AMBERLEIGH SHORES

NEW HANOVER COUNTY, NC

LAST REVISED - 12/05/12 (REV 14)

FLOURNOY DEVELOPMENT COMPANY
NEW HANOVER COUNTY, NC
AMBERLEIGH SHORES
PLAN REVISION SUMMARY

C2.1

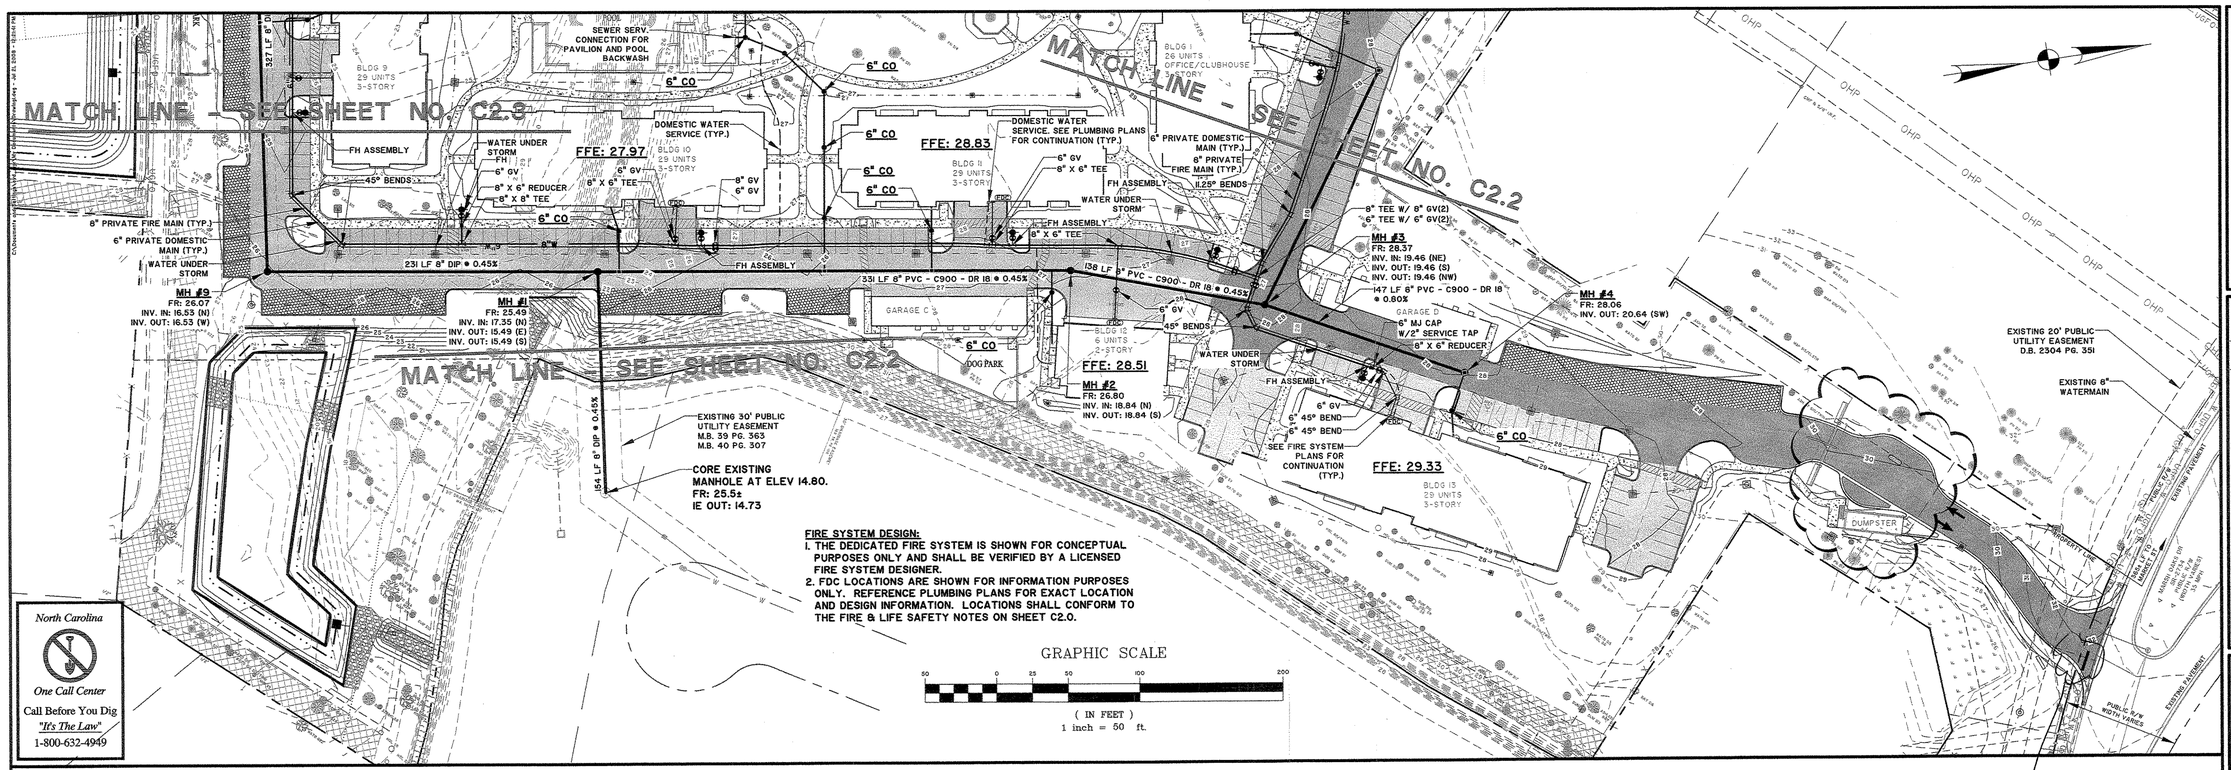
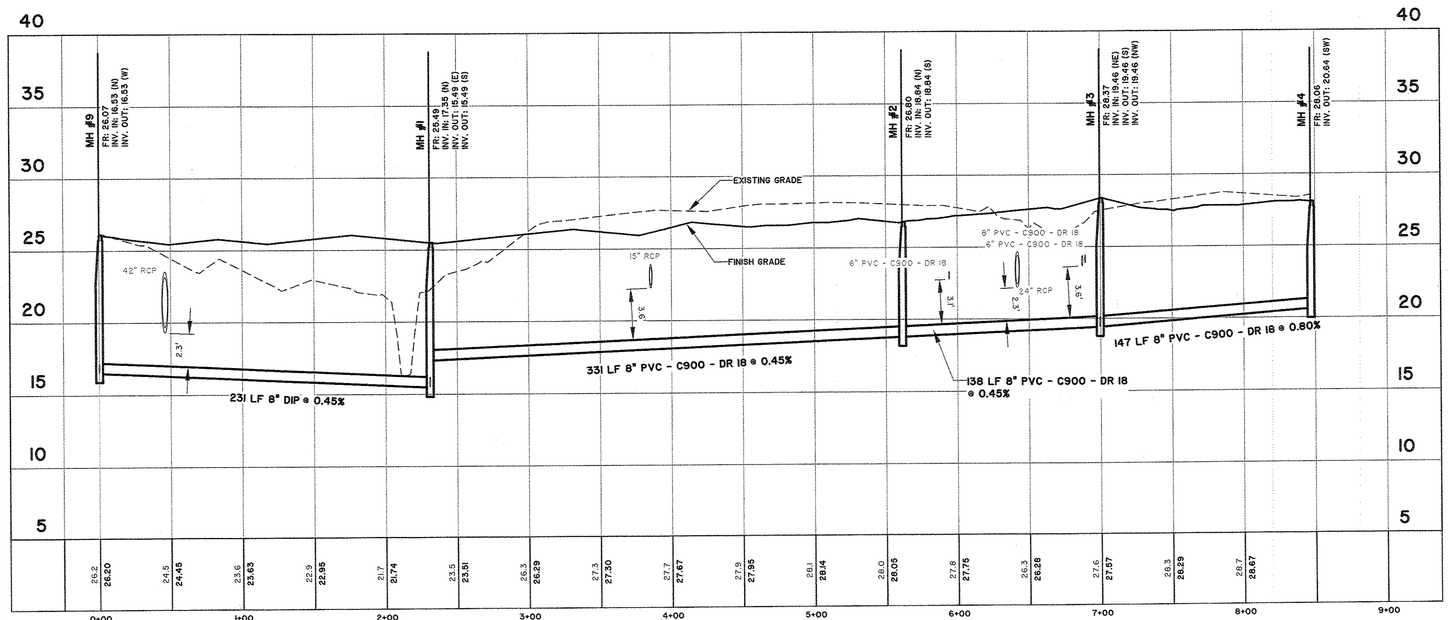
Sheet No.	Revision Comment
G1.0	Add Revision 7 Summary
C2.1	Add separation of utility crossings per NCDENR PWS
C2.3	Add separation of utility crossings per NCDENR PWS
C2.4	Add separation of utility crossings per NCDENR PWS

Stop bar to be 4' back from stop sign.
JDR
12-11-12

NO.	REVISIONS	BY	DATE
14	SEE REVISION SUMMARY ON SHEET G1.0	BDR	12/05/12
12	ADD PREVIOUS REVISION NOTES	BDR	08/27/12
7	ADD SEPARATION BEWTEEN CROSSINGS PER NCDENR	BDR	05/18/12
3	REVISE WATER ELEVATIONS AT SEWER CROSSINGS	BDR	03/27/12
2	PRIVATE WATER/SEWER (SEE SHEET G1.0 FOR MORE INFO)	BDR	03/09/12
1	SEE REVISION SUMMARY ON SHEET G1.0	BDR	01/25/12

C2.3

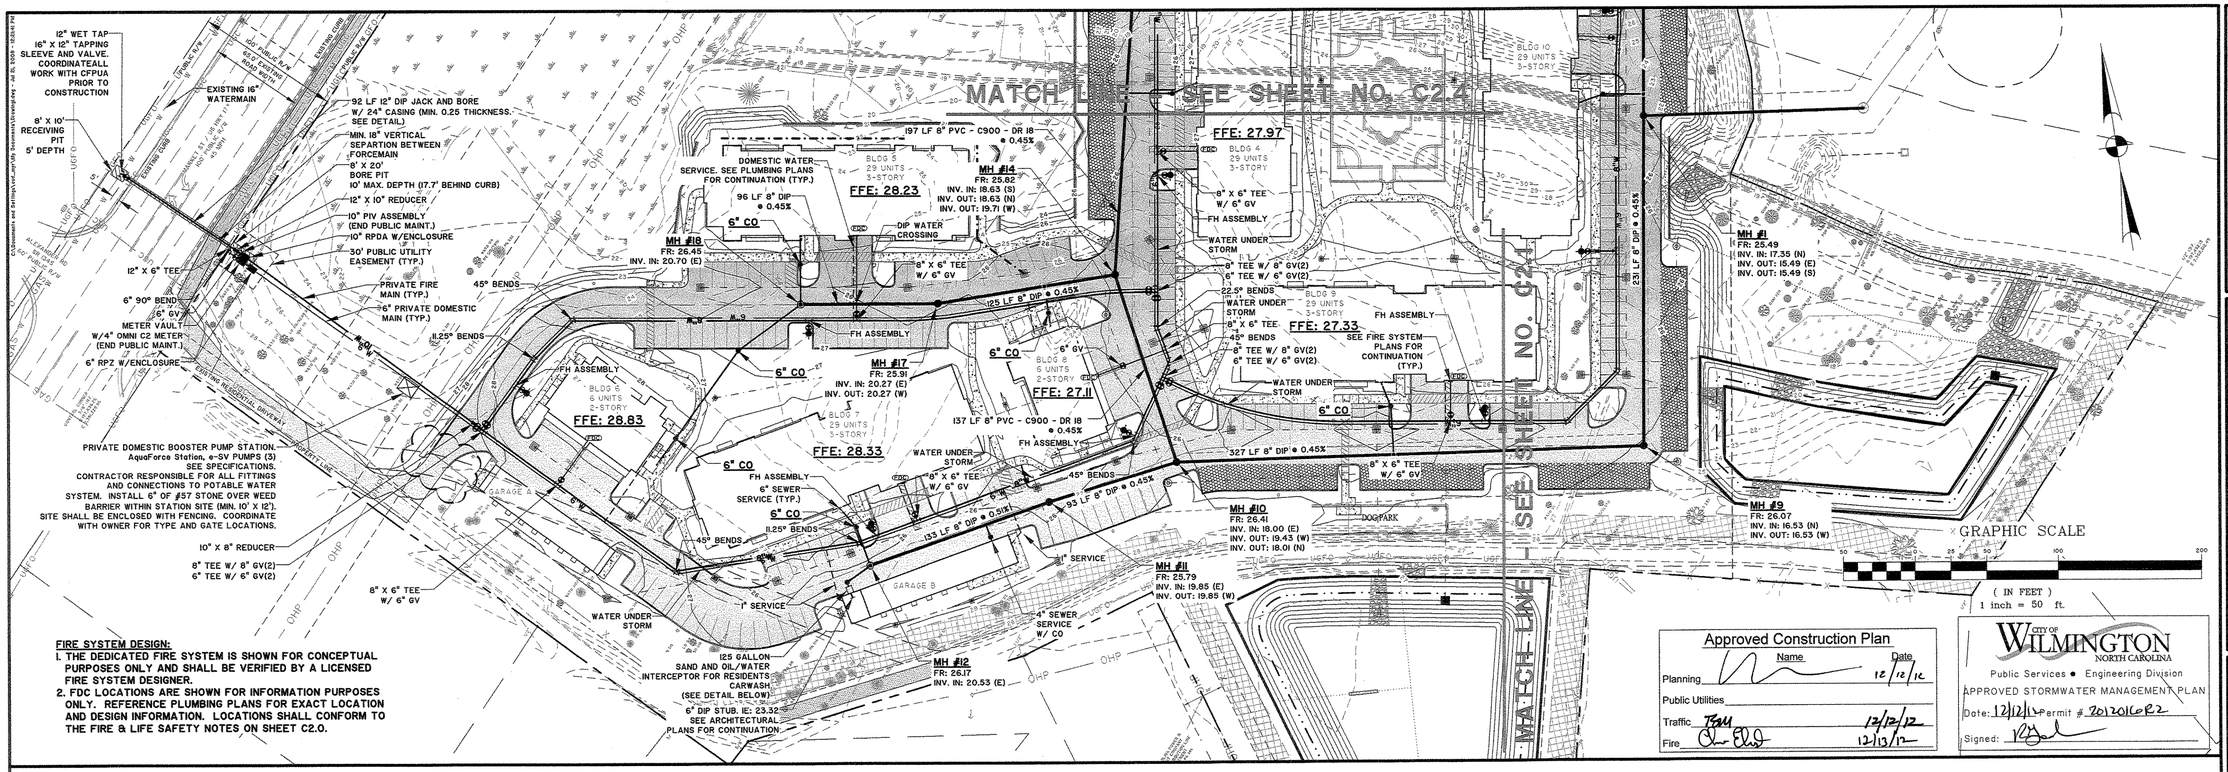
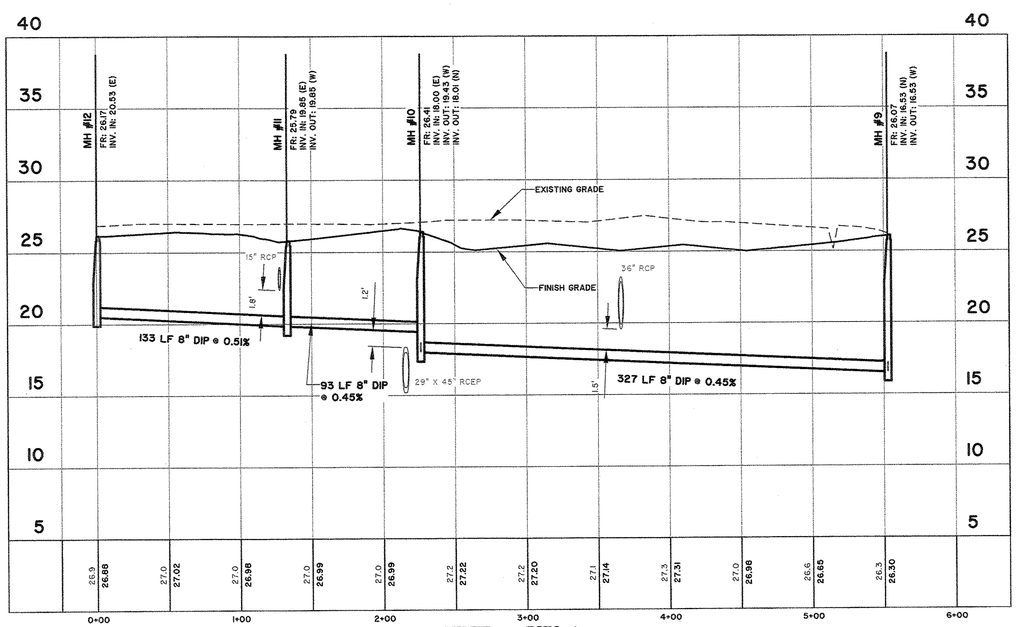
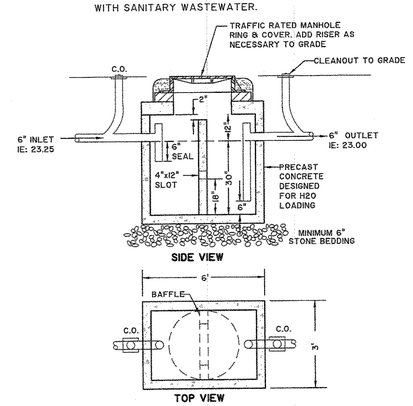
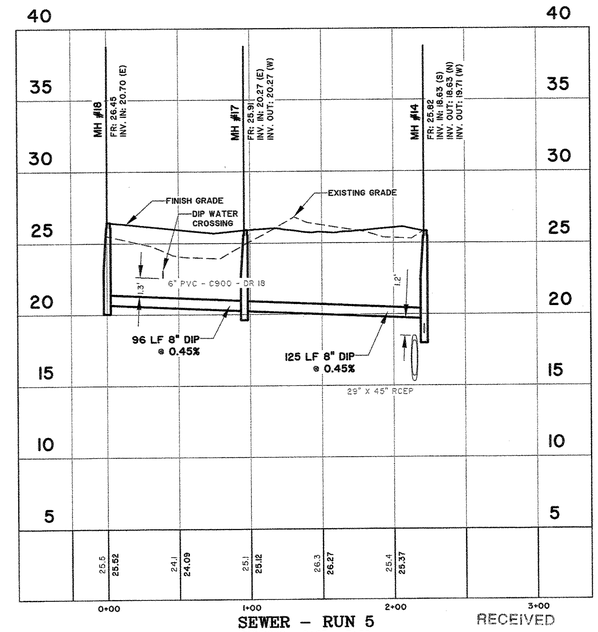
Sheet No.	Revision Comment
G1.3	Update Building Coverage and Impervious Summary Notes.
C2.3	Add note #2 to Sand and Oil/Water Separator Detail.
C3.2	Add Public Drainage Easement for the 29" x 45" elliptical storm drain pipe. Revise location of SMH #78.
C3.5	Add Public Drainage Easement for the 29" x 45" elliptical storm drain pipe.

NO.	REVISIONS	BY	DATE
14	REV. EMERGENCY GATE SYMBOL & FENCE LOCATION	BDR	12/05/12
12	ADD PREVIOUS REVISION NOTES	BDR	09/27/12
10	SEE REVISION SUMMARY ON SHEET G1.0	BDR	07/24/12
9	REVISE EMERGENCY ACCESS DRIVEWAY LOCATION	BDR	07/20/12
7	ADD SEPARATION BETWEEN CROSSINGS PER NCDENR	BDR	05/18/12
5	ADD NOTE #2 TO SEPARATOR DETAIL	BDR	04/23/12
3	CFPUA REVISIONS (SEE SHEET G1.0 FOR MORE INFO)	BDR	03/27/12
2	PRIVATE WATER/SEWER (SEE SHEET G1.0 FOR MORE INFO)	BDR	03/09/12
1	SEE REVISION SUMMARY ON SHEET G1.0	BDR	00/29/12

C3.3

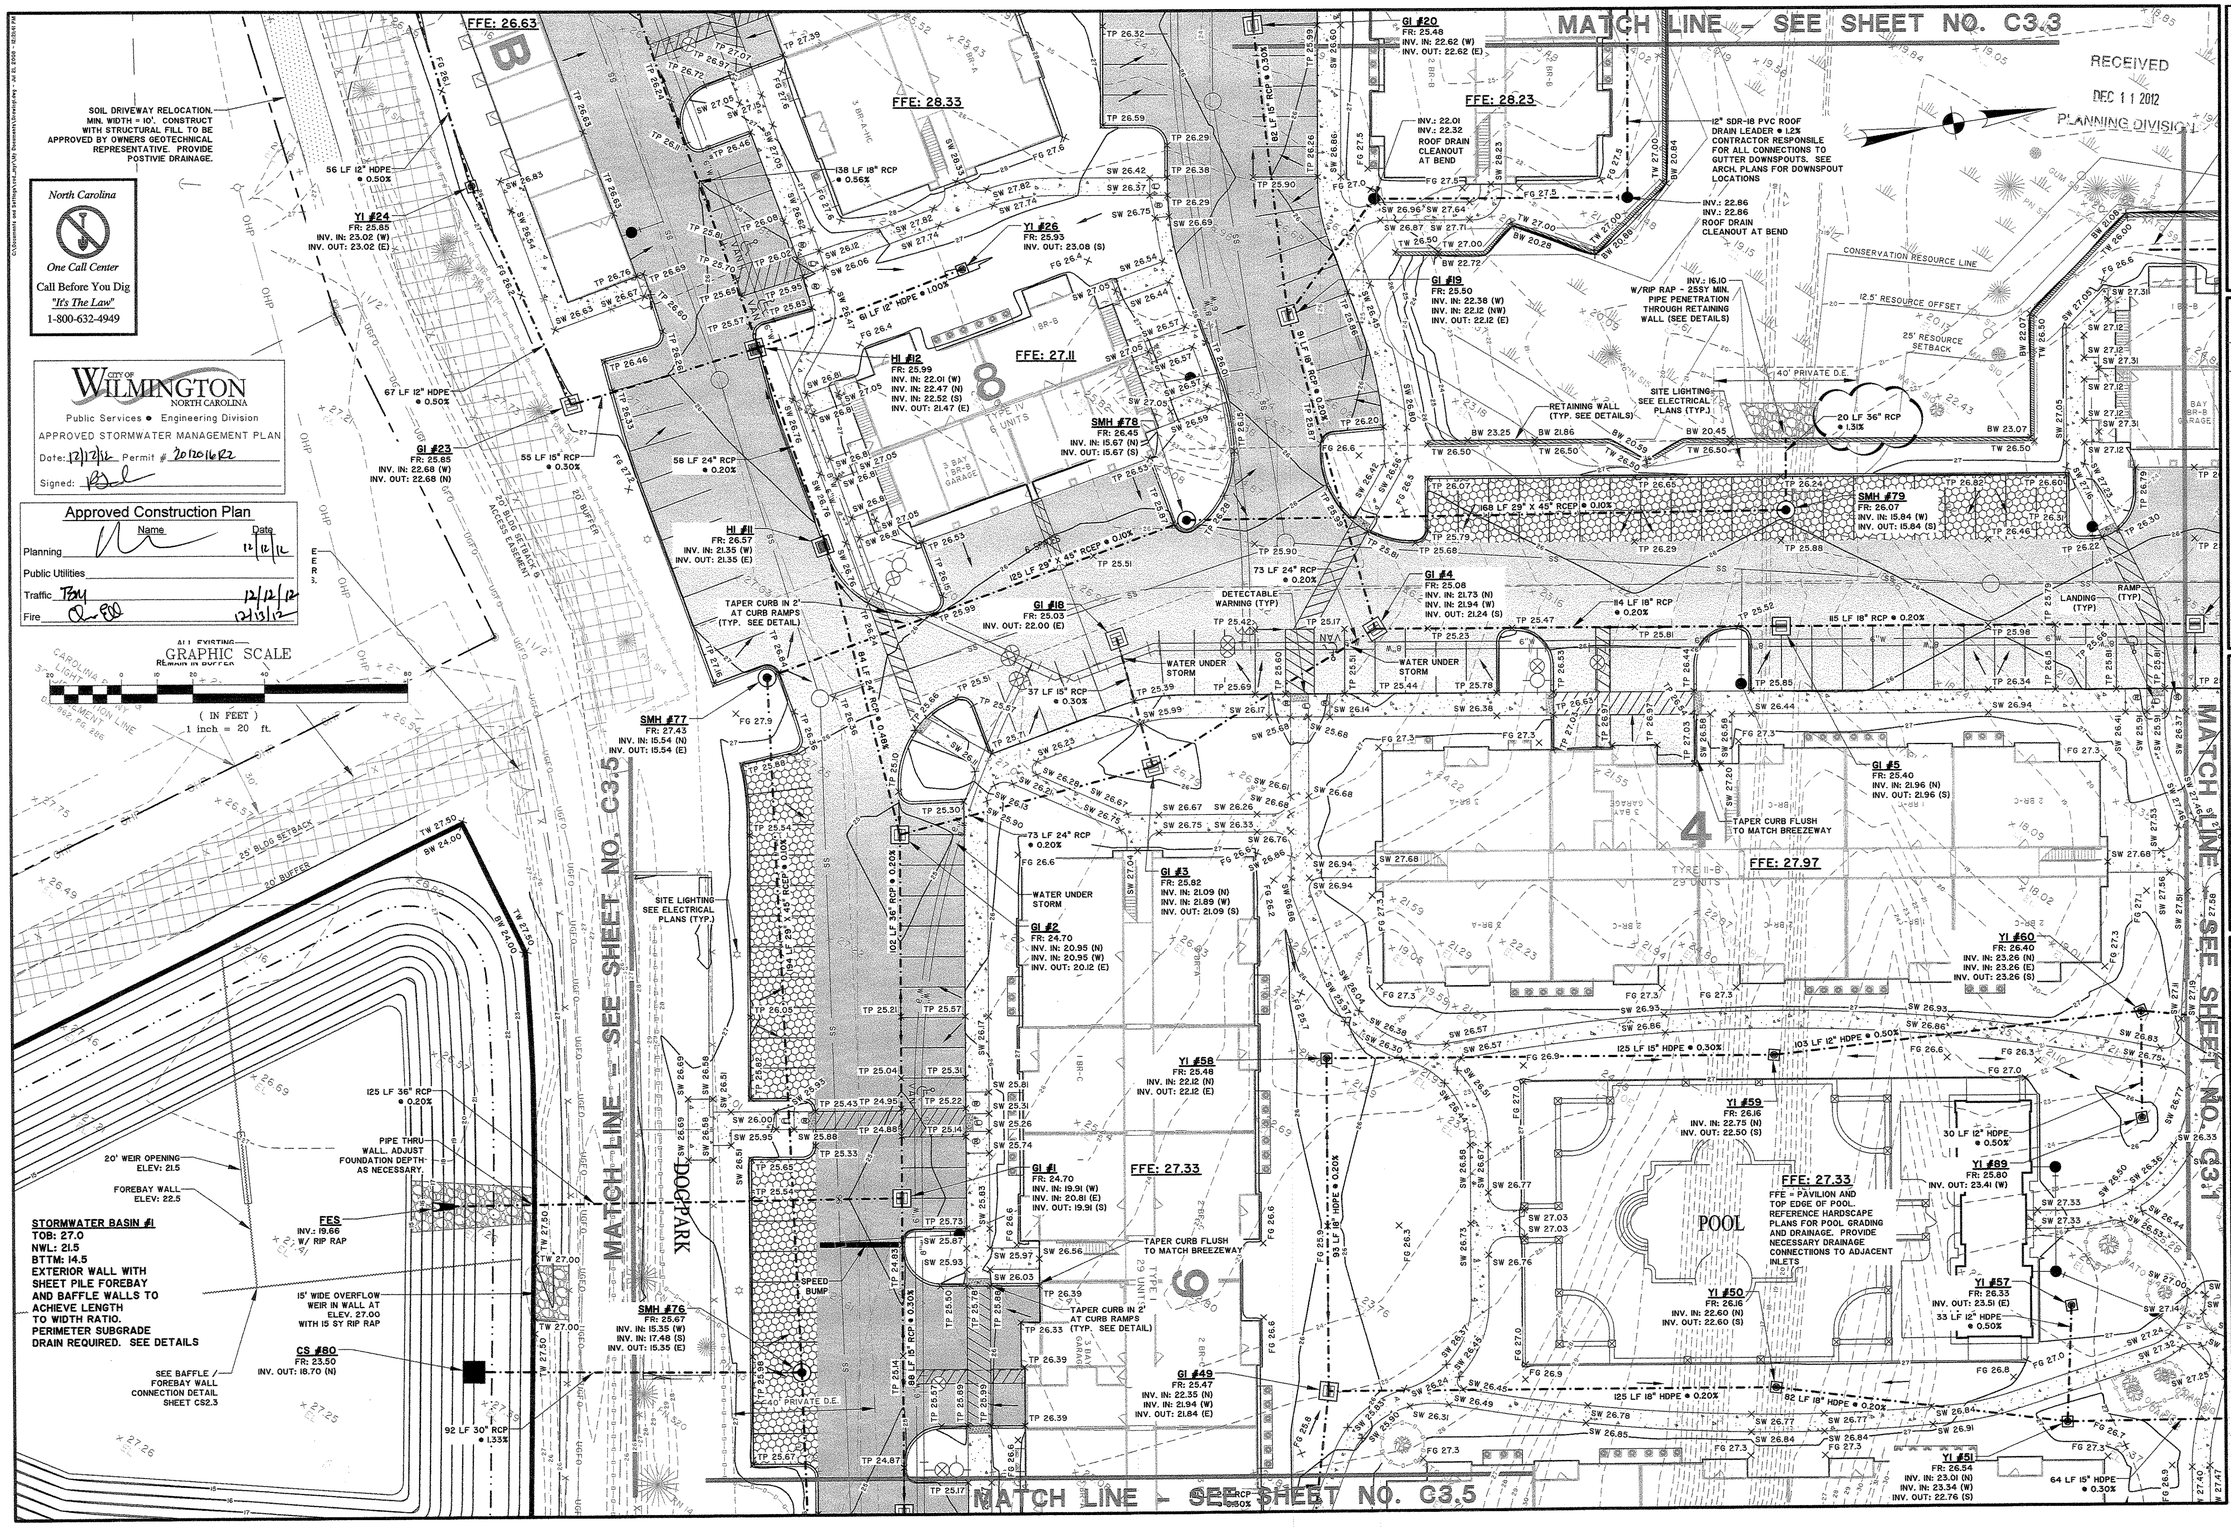
NO.	REVISIONS	BY	DATE
14	DELETE CONCRETE STRIP AT EMERGENCY GATE	BDR	12/05/12
12	ADD PREVIOUS REVISION NOTES	BDR	08/27/12
10	SEE REVISION SUMMARY ON SHEET G.0	BDR	07/24/12
4	SEE REVISION SUMMARY ON SHEET G.0	BDR	04/23/12
1	SEE REVISION SUMMARY ON SHEET G.0	BDR	01/25/12
